Proposed changes to 802.3ca - D2.1 PMA figures 142-19 & 142-20

Bill Powell - FN CTO Group, Raleigh

September, 2019

Indianapolis, IN meeting

Figure 142-19—Differential encoding

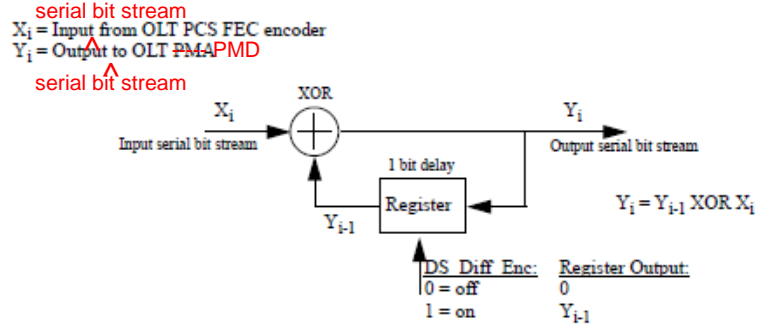
- Propose to add notes to Figures 142-19 and 142-20 to address concerns expressed by a D2.0 voter
